**IMPERIAL ROAD DESIGN MANUAL**  
**REVISIONS July, 2013**

## ***PLANS***

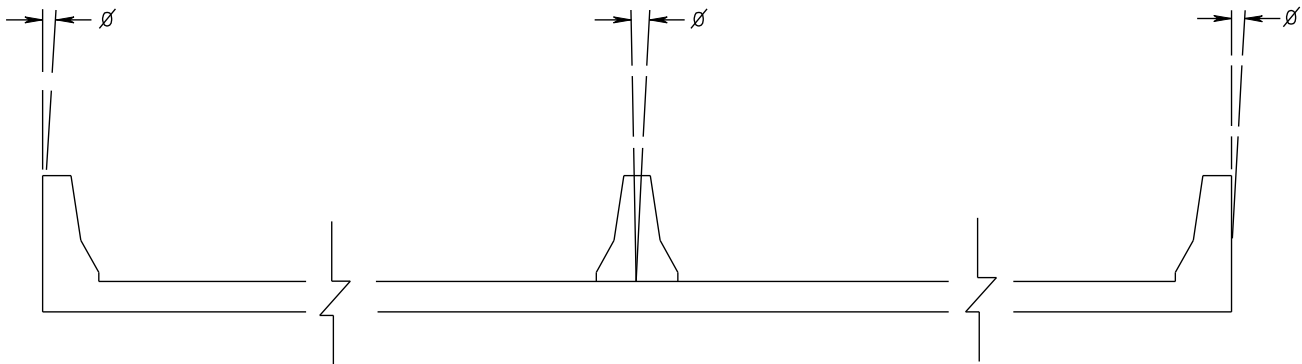
- Page 2E-25 & 26 – Relocated the following language to Appendix “A”;  
***POLICY FOR CONSTRUCTION OF CONCRETE BARRIER & RETAINING WALLS ON SUPERELEVATIONS***

- *Concrete Barriers on roadway approaches should be designed with the same shape (K type) and angle of inclination as the parapet face and concrete median barriers on the bridge.*
- *The Standard GS-11 has a 7% algebraic difference for the shoulder break on the outside of a superelevated section. The bridge deck has a straight super between parapet walls making it necessary to spline the shoulder grade of the roadway to match the bridge deck slope. Under normal conditions, this can be accomplished by a 200' transition.*

*The same principle would apply to the low side of the roadway. Should the superelevation of the bridge deck be less than the slope of the inside shoulder, then it would be necessary to spline the shoulder grade to match the bridge deck. The length of transition is to be obtained by using sound engineering practices.*

- *When concrete barriers are tied into the bridge parapets and median, a general note will need to be included in the plans specifying:*

<i>“The Contractor is to transition the Concrete Barrier so that the face will align with the face of the bridge parapets and median.”</i>
--

- *The roadway development is to be closely coordinated with bridge design in the approach area.*

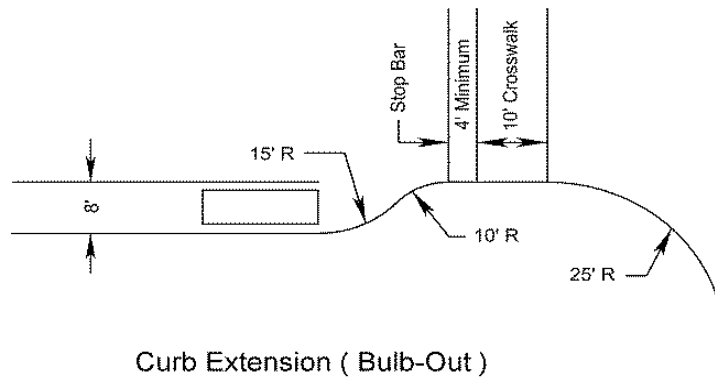
- Page B(1)-57 – Revised the following language in the third sentence in item “F” from;

Curb Extensions – Curb extensions at intersections are frequently used in Traditional Neighborhood Developments. Curb Extensions are usually found on higher volume streets where they are used to protect parking areas or reduce pedestrian crossing times. For intersections with curb extensions, a minimum 35’ radius should be used as in the sketch below. Intersection chokers or curb extensions can also be used to calm traffic and to shorten the distance pedestrians must travel to cross a street.

To;                    “Curb Extensions – Curb extensions at intersections are frequently used in Traditional Neighborhood Developments. Curb Extensions are also used to protect parking areas and to reduce pedestrian crossing times.”

Added the following language to the end of Item “F”

*Note: The sight distance triangle shall be free of any obstructions that block a driver's view of potential conflicting vehicles or pedestrians entering the traveled way. Examples of obstructions that limits sight distance include vehicles in adjacent lanes, parked vehicles, bridge piers and abutments, large signs, poorly pruned trees, tall shrubs and hedges, walls fences and buildings.*
